Torque Converter Flex Lock-up Shudder

Service Category Drivetrain

Section Automatic Transmission/Transaxle

YEAR(S)	MODEL(S)	ADDITIONAL INFORMATION
2013 – 2014	RAV4	Drive Type(s): 4WD, 2WD VDS(s): BF4EV, BFREV, DF4EV, DFREV, RF4EV, RFREV, WF4EV, WFREV, YF4EV, YFREV, ZF4EV, ZFREV

Figure 1. Magnet Installation Locations

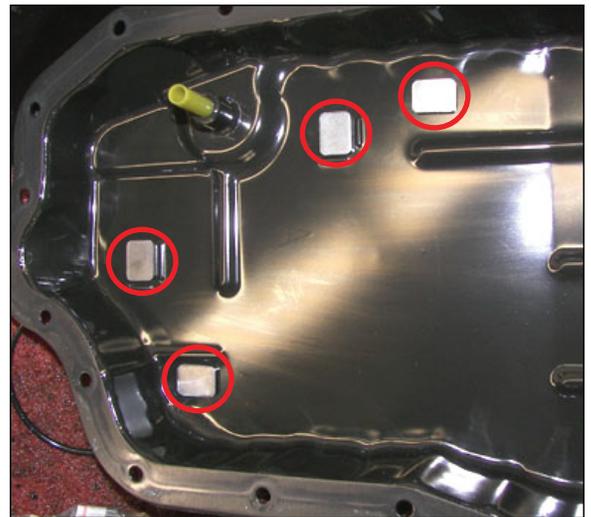
- Install 4 NEW magnets in the locations shown in Figure 1.

Figure 2. Location of Authorized Modifications Label on 2013 – 2014 RAV4

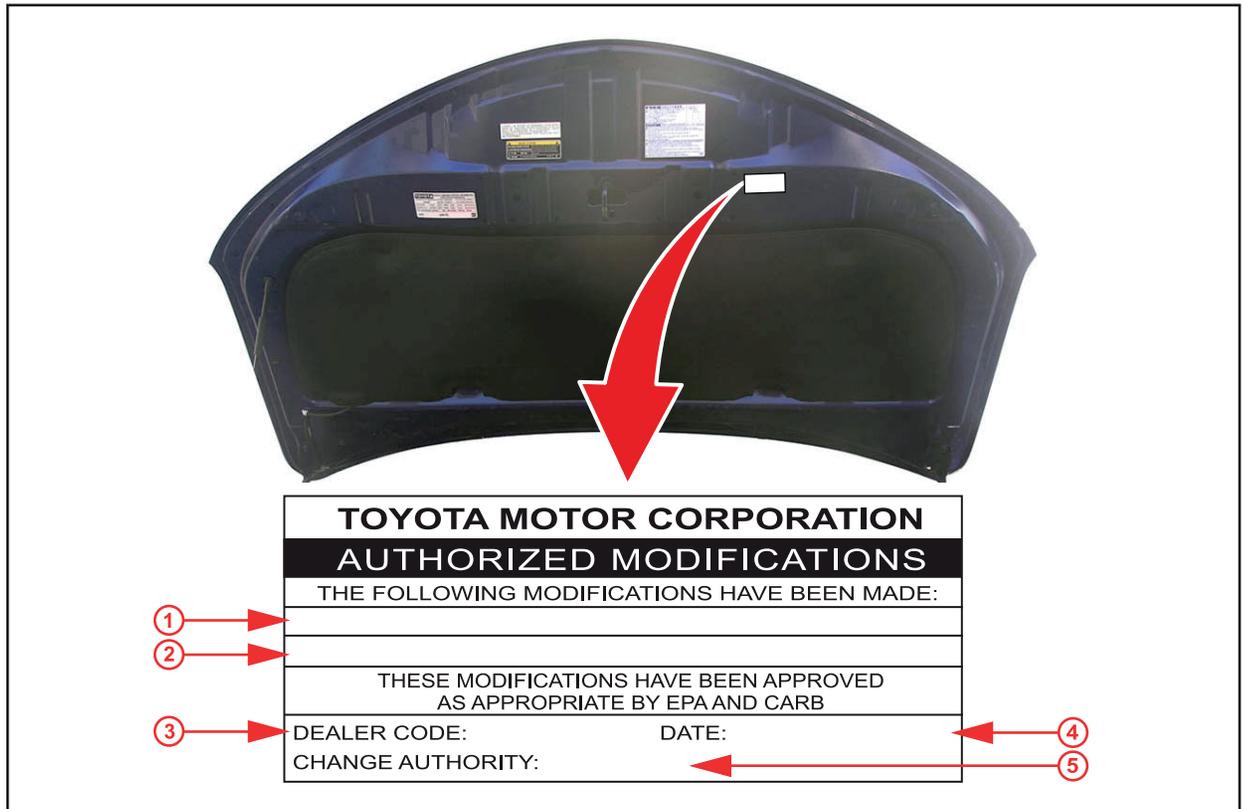
- 2013 – 2014 RAV4:
Drivetrain – Automatic Transmission/Transaxle – “[U760E](#) / [U760F](#) Automatic Transmission/Transaxle: Automatic Transaxle Fluid: Replacement”
9. Check for the Authorized Modifications Label affixed to the vehicle in the location shown in Figure 2 below. Confirm if the ECM (PCM) calibration has been updated. If the calibration ID listed is NOT the latest ECM (PCM) calibration — go to step 10. If the calibration ID is the latest, go to step 12.

11. Install the Authorized Modifications Label.
 - A. Using a permanent marker, enter the following information on the label:
 - ECM part number [Refer to the **Parts Information** section for the **NEW PART NUMBER**]
 - Calibration ID(s) [Refer to the **Calibration Information** section for the **NEW CALIBRATION ID**]
 - Dealer Code
 - Repair Date
 - Change Authority [**This bulletin number**]
 - B. Affix the Authorized Modifications Label to the vehicle at the location shown in Figure 2. The Authorized Modifications Label is available through the MDC, P/N 00451-00001-LBL.
12. Perform the Techstream ECT Reset Memory Utility and test drive to confirm the repair.
